JOSEPH M. FARLEY NUCLEAR PLANT, UNIT 1

AMENDMENT TO FACILITY OPERATING LICENSE

Amendment No. 147
License No. NPF-2

ATTACHMENT TO LICENSE AMENDMENT No. 147

Figure 3.4.16-1

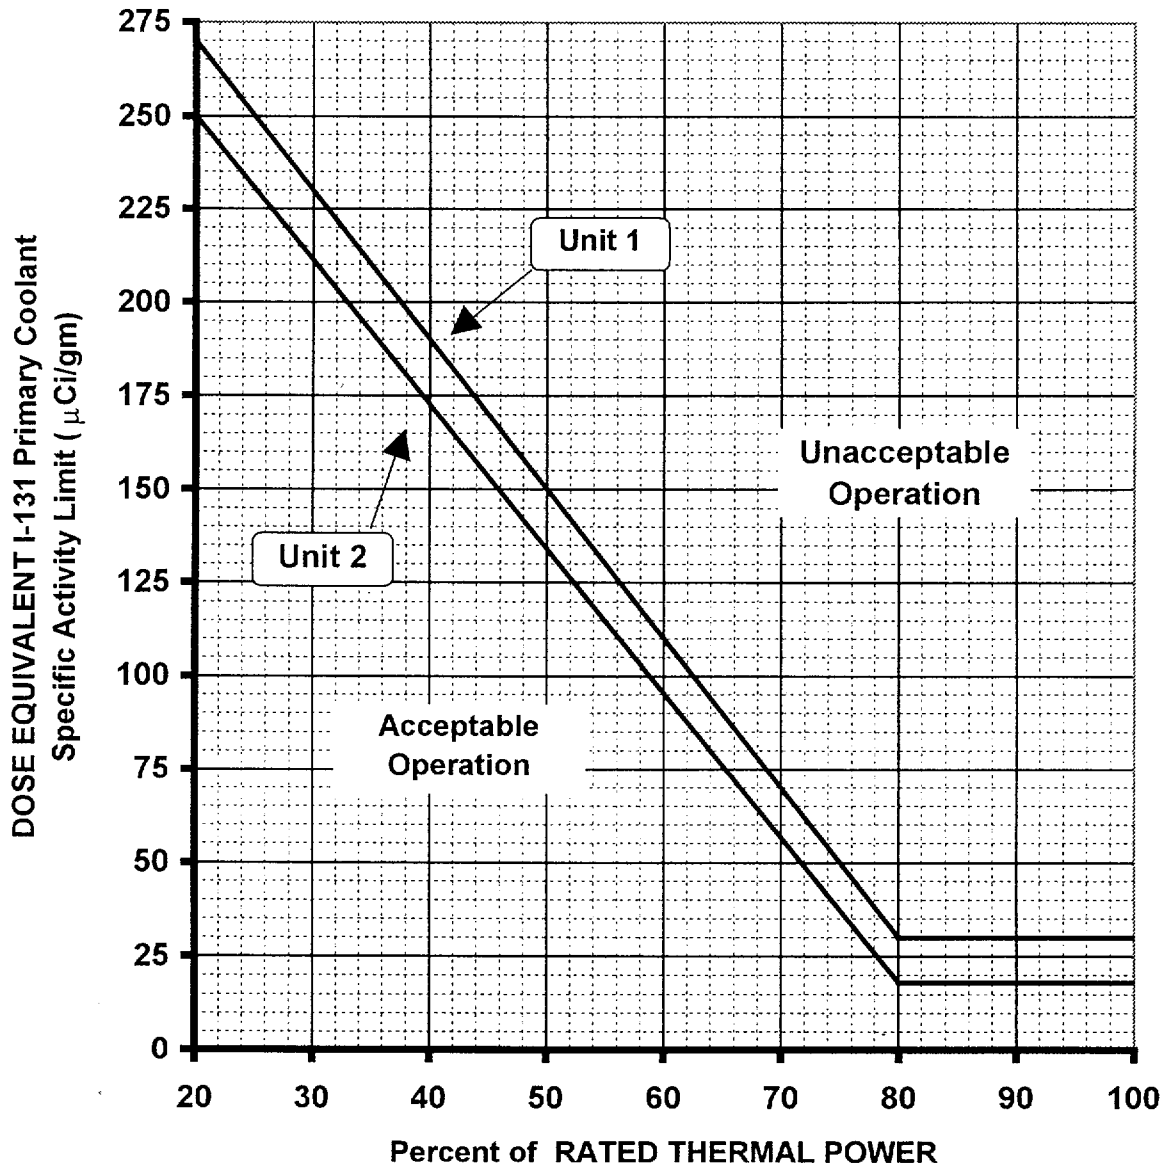
CONDITION	REQUIRED ACTION	COMPLETION TIME
A. DOSE EQUIVALENT I-131 [Unit 1 only: > 0.5 μ Ci/gm] [Unit 2 only: > 0.30 μ Ci/gm].	-----Note----- LCO 3.0.4 is not applicable. -----	Once per 4 hours
	A.1 Verify DOSE EQUIVALENT I-131 within the acceptable region of Figure 3.4.16-1.	
	<u>AND</u>	
	A.2 Restore DOSE EQUIVALENT I-131 to within limit.	48 hours
B. Gross specific activity of the reactor coolant not within limit.	B.1 Be in MODE 3 with $T_{avg} < 500^\circ\text{F}$.	6 hours

CONDITION	REQUIRED ACTION	COMPLETION TIME
<p>C. Required Action and associated Completion Time of Condition A not met.</p> <p><u>OR</u></p> <p>DOSE EQUIVALENT I-131 in the unacceptable region of Figure 3.4.16-1.</p>	<p>C.1 Be in MODE 3 with $T_{avg} < 500^{\circ}\text{F}$.</p>	<p>6 hours</p>

DOSE EQUIVALENT I-131 Primary Coolant Specific Activity Limit Versus Percent of RATED THERMAL POWER with the Primary Coolant Specific Activity [Unit 1 only: > 0.5 µCi/gm] [Unit 2 only: > 0.30 µCi/gm] DOSE EQUIVALENT I-131.

Figure 3.4.16-1

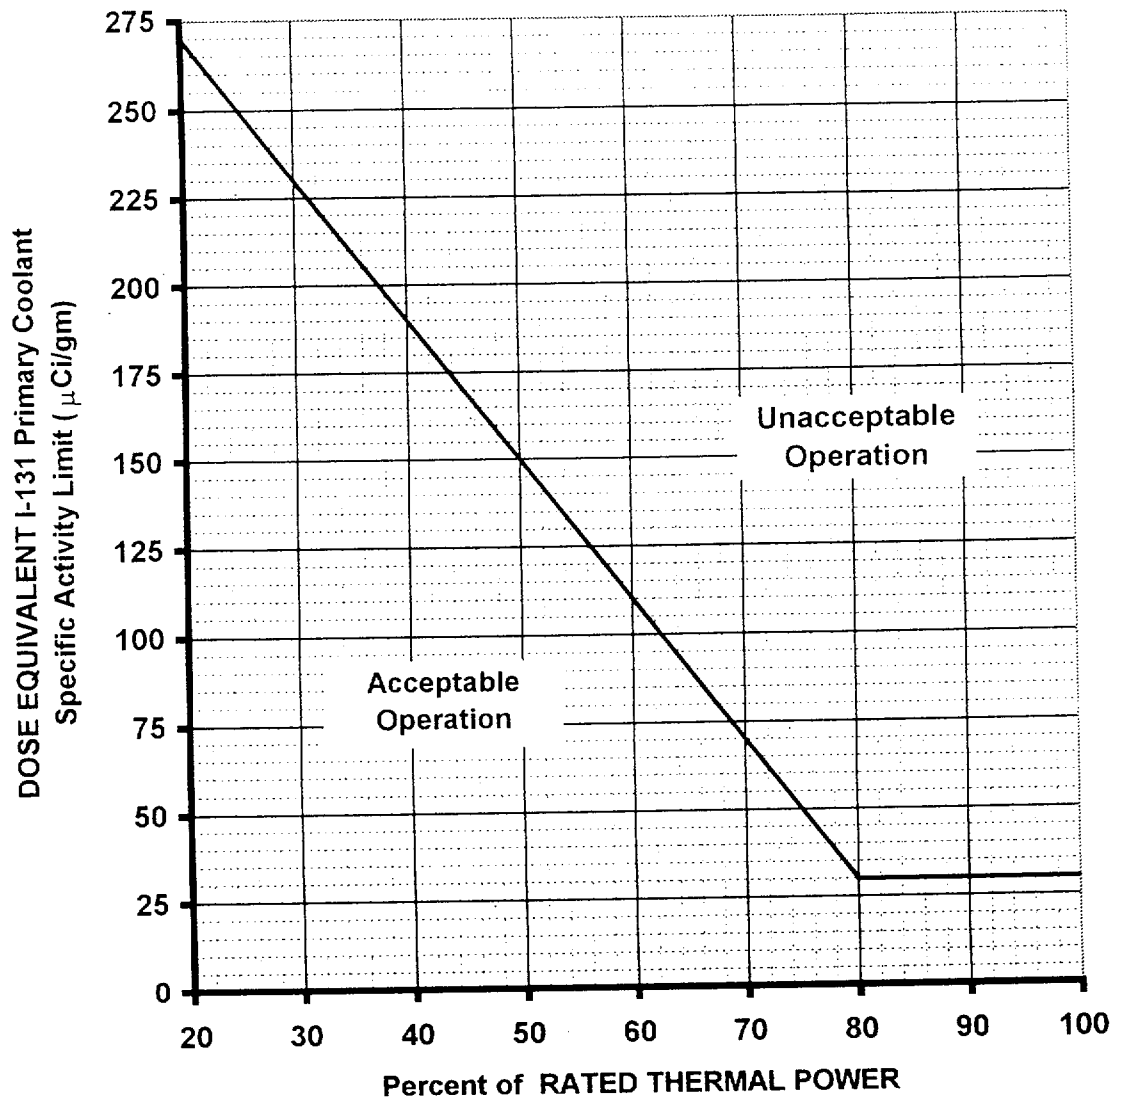
CONDITION	REQUIRED ACTION	COMPLETION TIME
A. DOSE EQUIVALENT I-131 $>$ 0.5 μ Ci/gm.	-----Note----- LCO 3.0.4 is not applicable. -----	Once per 4 hours
	A.1 Verify DOSE EQUIVALENT I-131 within the acceptable region of Figure 3.4.16-1.	
	<u>AND</u>	
	A.2 Restore DOSE EQUIVALENT I-131 to within limit.	48 hours
B. Gross specific activity of the reactor coolant not within limit.	B.1 Be in MODE 3 with $T_{avg} <$ 500°F.	6 hours

CONDITION	REQUIRED ACTION	COMPLETION TIME
C. Required Action and associated Completion Time of Condition A not met. <u>OR</u> DOSE EQUIVALENT I-131 in the unacceptable region of Figure 3.4.16-1.	C.1 Be in MODE 3 with $T_{avg} < 500^{\circ}F.$	6 hours

DOSE EQUIVALENT I-131 Primary Coolant Specific Activity Limit Versus Percent of RATED THERMAL POWER with the Primary Coolant Specific Activity $> 0.5 \mu\text{Ci/gm}$ DOSE EQUIVALENT I-131.
